NOTICE OF REGULAR MEETING OF THE PLANNING AND ZONING COMMISSION HICKORY CREEK TOWN HALL 1075 RONALD REAGAN AVENUE, HICKORY CREEK, TEXAS 75065 TUESDAY, JANUARY 21, 2025, 6:00 PM

AGENDA INFORMATION SHEET

Re: Victory Phase 2 Hickory Creek (Lot 9, Block A – Lennon II Addition)

Re: Victory Phase 2 Hickory Creek (Lot 9, Block A – Lennon II Addition)
Site Plan and Landscape Plan

FINAL PLAT LENNON II ADDITION LOT 9, BLOCK A

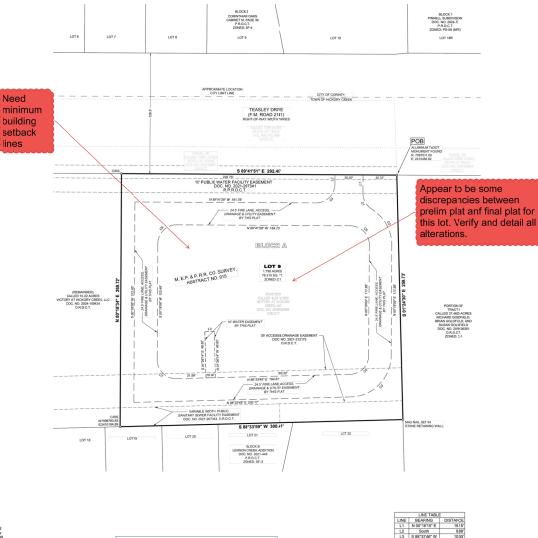
- 1. Refer to attached Town checklist markups for additional comments.
- 2. Refer to attached plat markup for all additional comments.
- 3. Update all years in signature blocks to 2025.

- 1. Please include minimum building setback lines for front, side and rear lot per Town Zoning Ordinance requirements and zoning designation.
- 2. Please submit tax certificates or tax statement(s) proving payment of taxes on property.
- 3. There are discrepancies between the approved preliminary plat for this lot and this final plat. Please provide letter fully outlining all alterations from the approved Preliminary Plat.

Attachment: Site and Landscape Plan markups

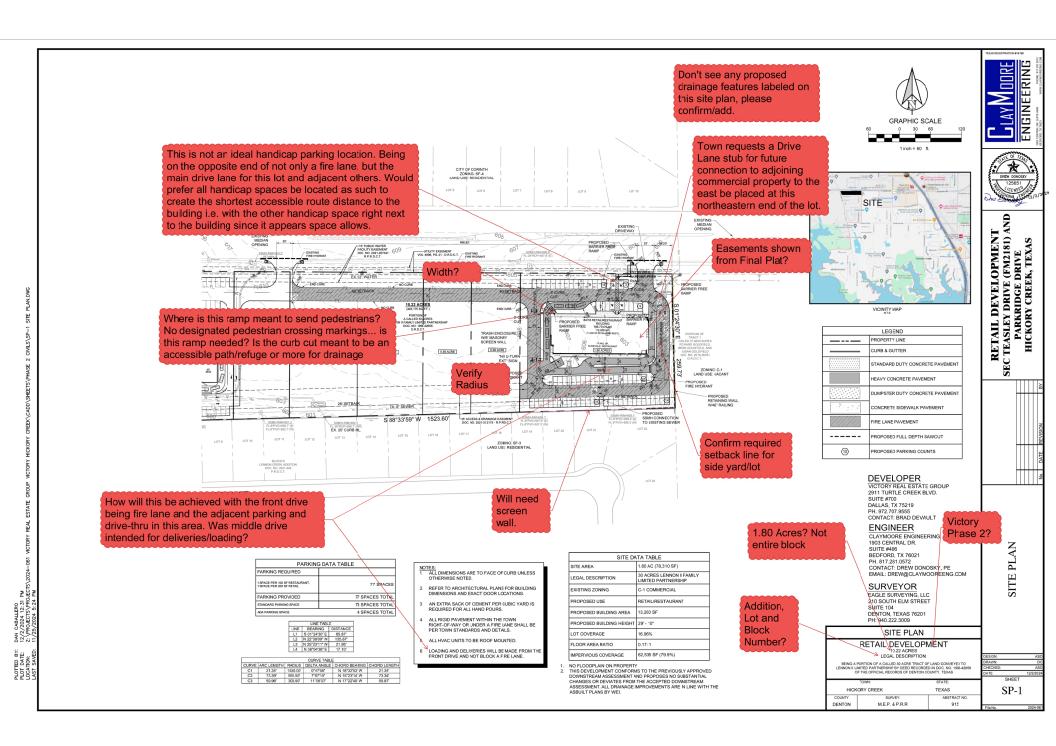
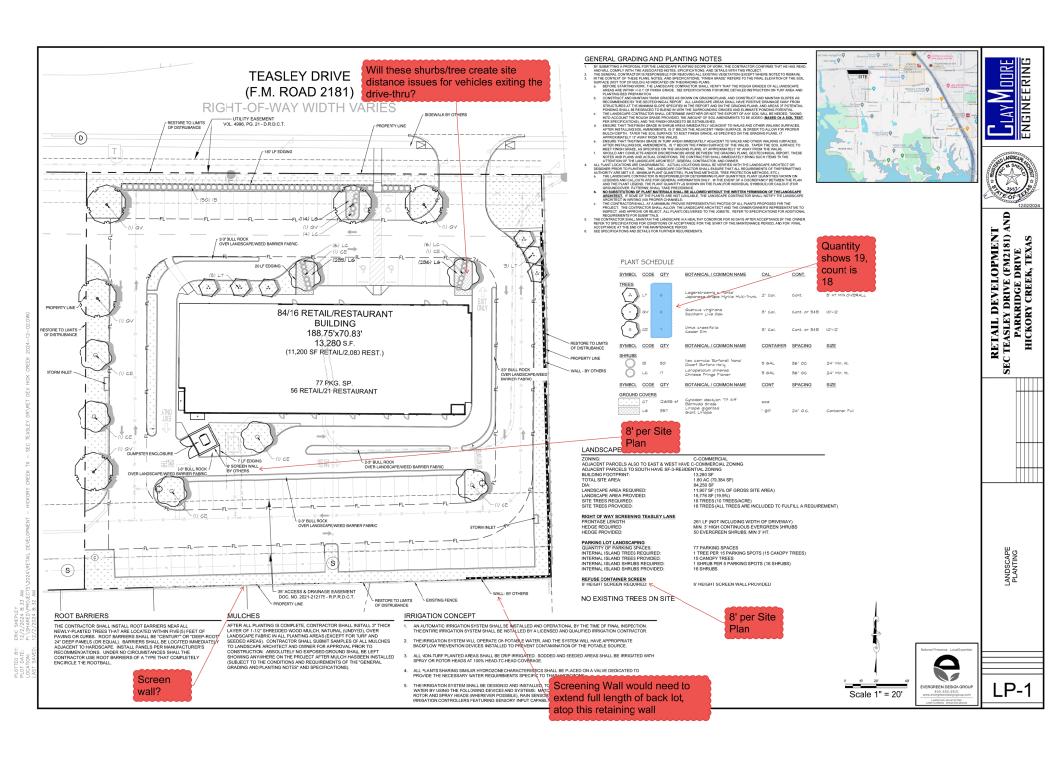
- 1. Refer to Town checklist markup for additional comments.
- 2. Refer to attached markups for all additional comments.
- 3. Please address comments and markups on the attached markups and provide response letter and annotated responses on plans.

- 1. For the Title Block in the lower right corner, please include the subdivision/addition name with lot and block number are missing, acreage needs to be revised to reflect the lot's acreage (not full block), and development name should be updated as appropriate.
- 2. Please consider relocation of the two handicap parking spaces across the front drive/fire lane. See Markup.
- 3. Please include minimum building setback lines for side lot per Zoning Ordinance requirements.
- 4. Please verify the designated delivery or loading and unloading area (i.e. delivery/freight trucks), the current note appears to be pulled from the Phase 1 site plan and is inaccurate for this site's layout.

- 5. Please provide the size, location, dimensions and details of all signs and exterior lighting of signs, including type of standards, locations and radius of light and intensity of foot-candles. If none, please confirm. Building elevations show lighting for building. All signage and exterior building lighting is subject to approval by the Building Inspections Department.

- 1. Please show and label all screening walls, fences, retaining walls, headlight screens and service area screens, including heights and types, as needed on the Landscape Plan. Refer to Site Plan comment regarding required masonry screen wall along southern boundary.
- 2. Please correct discrepancy in dumpster enclosure height between the site plan and landscape plan.
- 3. Please update the quantity of trees shown in the plant material tables vs what is shown in the plan and called for in "Trees Provided" section.
- 4. Please see markups for comment requesting confirmation there is no site distance issue with trees and shrubs at the exit of the south/eastern drive thru lane.
